RE: Approval of license Amendment for Western Nuclear, Inc. Split Rock Site, WYSUA-56, TFN 6-5-344, Amendment 111.

**STATE DECISION DOCUMENT
TECHNICAL REVIEW OF WESTERN NUCLEAR INC SPLIT ROCK URANIUM
MILL ALTERNATE CONCENTRATION LIMIT FOR NITRATE IN GROUNDWATER
IN THE SOUTHWEST VALLEY**

LICENSE AMENDMENT REQUEST

Figure 1: Influence of groundwater velocity on time before ACL results in nitrate MCL at the POE

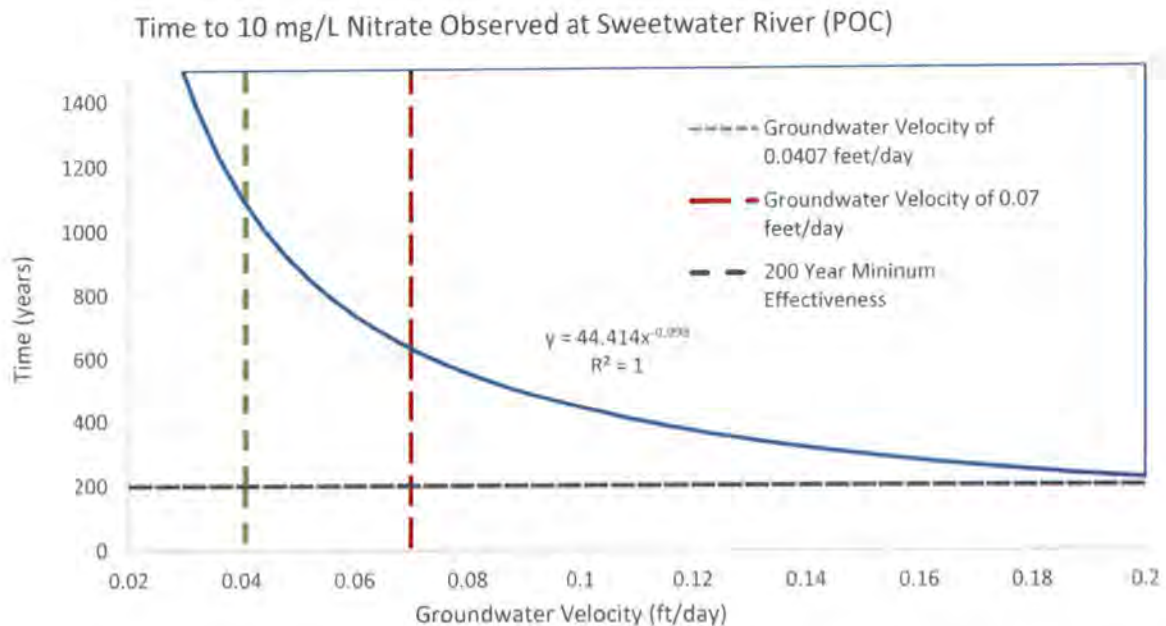
To estimate the sensitivity of the velocity parameter, the model was run numerous times using various groundwater velocity inputs. The fitted curve in Figure 1 corresponds with the results of those runs. The time where 10 mg/L of nitrate is observed at the POE in the model, the Sweetwater river, varies according to the relationship:

$$t = 44.414v^{-0.998}$$

Where t is the time in years at which a concentration of 10 mg/L is observed at the river, and v is the groundwater velocity in feet/day

Assuming the lower end porosity estimated in the 1999 WNI Split Rock Groundwater Protection Plan (GWPP) (0.25) and the geometric mean hydraulic conductivity (7.36 feet/day), a velocity of 0.072 feet per day is calculated. Assuming these values, the time at which 10 mg/L may be observed at the POE would be 615 years. However, the best estimate of porosity is likely higher than 0.3, as observed in the laboratory testing completed in the 1999 GWPP, and as estimated by WNI (Aquifertek, 2016). This testing estimated porosities greater than 0.35, and the 1999 model was run using an estimate of 0.35. The hydraulic conductivity of 5 feet per day is based on model calibrations using pump tests and evaluating hydraulic head at the wells in the southwest valley. This estimate therefore is considered the best estimate of hydraulic conductivity. Thus, the velocity used in the ATRANSI model is likely conservative.

Addendum 1

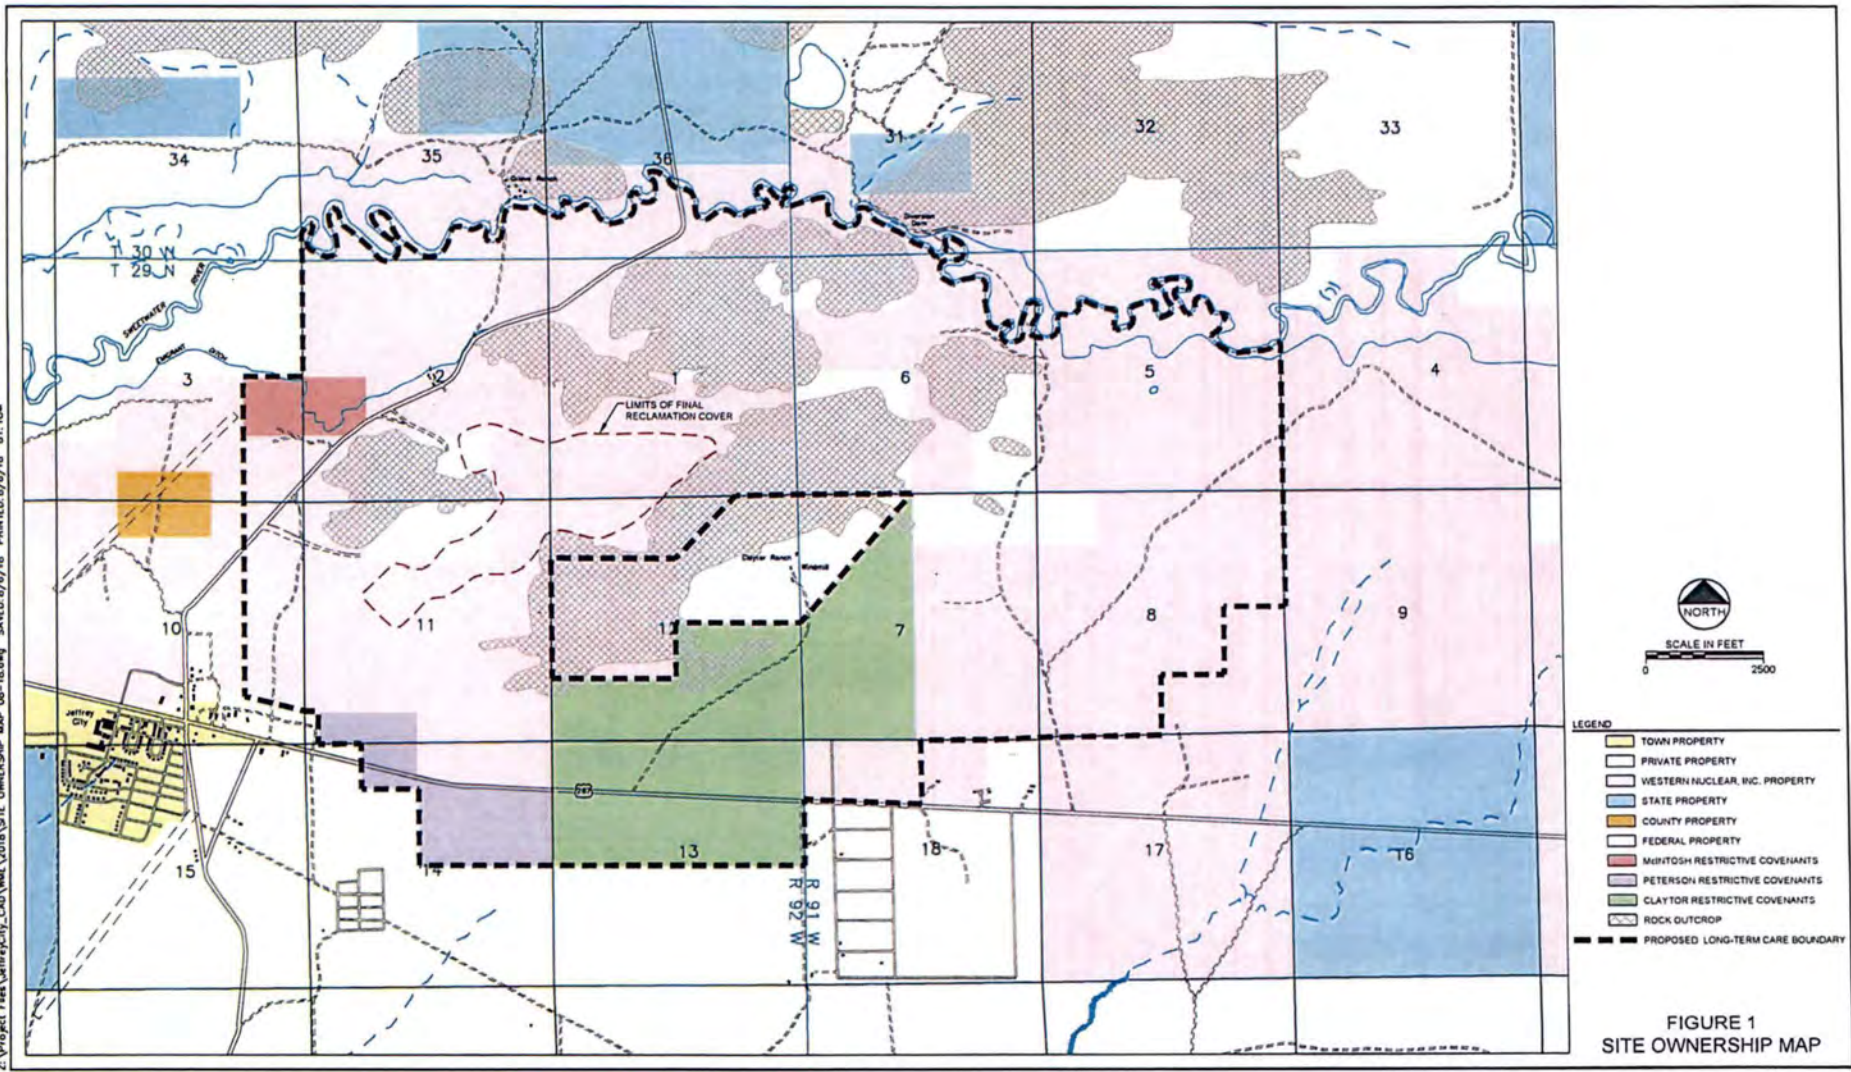
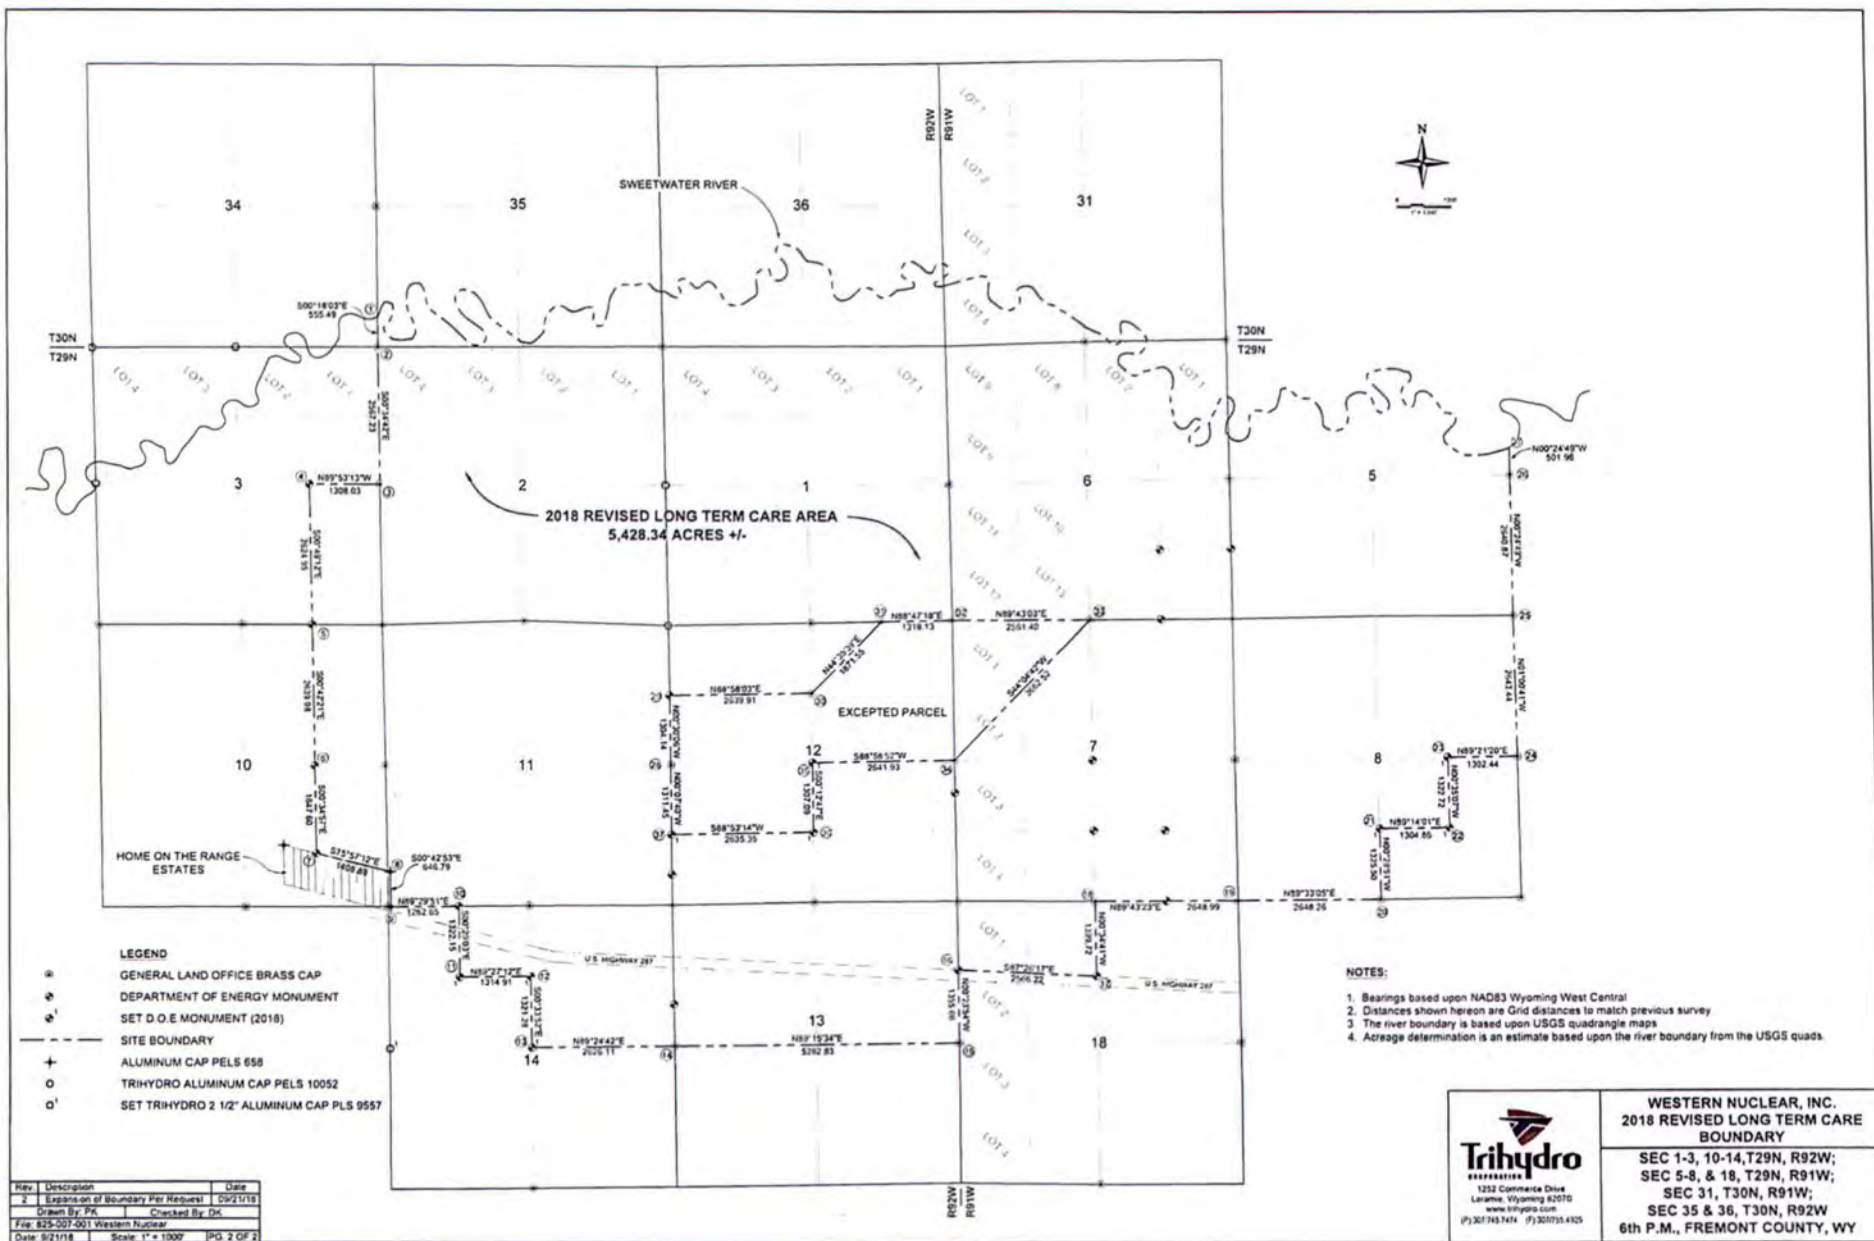
The LTSB extension is necessary so that the nitrate plume, over the 1000 year timeframe, does not come into contact with humans, livestock, or wildlife via the drinking water pathway. Therefore, this amendment is also approved. The proposed LTSB provided by WNI is shown in addendum 1. The extension of the LTSB, although specifically completed for the nitrate plume, would improve the confidence of previous ACL decisions made by the NRC for constituents in the SW Valley. The evaluation of nitrate, which used very conservative assumptions, would equally be bounding for any other constituent of concern, and thus is protective of all previously approved ACLs.

As stated in 10 CFR 40.28(b), “the general license in paragraph (a) of this section [for the Department of Energy’s Long-Term Surveillance and Maintenance] becomes effective when the Commission terminates, or concurs in an Agreement State’s termination of, the specific license and the site Long-Term Surveillance Plan (LTSP) meeting the requirements of this section has been accepted by the Commission.” The DOE is required to submit the LTSP to the NRC which will include both a proposed long-term environmental monitoring program and the proposed LTSB as discussed in 10 CFR 40.28(1), (2), and (3). Upon review and approval of the LTSP, the LTSB and long-term monitoring program, pursuant to the general license in 10 CFR 40.28 becomes effective. While the groundwater monitoring wells proposed by WNI for the SW Valley would be considered protective for near-term monitoring in comparison to the 1000 year compliance period, the prolonged transport times for constituents to reach the LTSB reduce their effectiveness for determining potential health and safety impacts at the POE. Thus, groundwater monitoring may not be necessary in the SW Valley following license termination due to the proposed LTSB expansion, with potentially only surface water samples needing to be collected at the proposed Sweetwater River sampling points. Therefore, the LTSB extension as presented in addendum 1 and WNI’s January 11th, 2019 letter to the LQD is also approved.
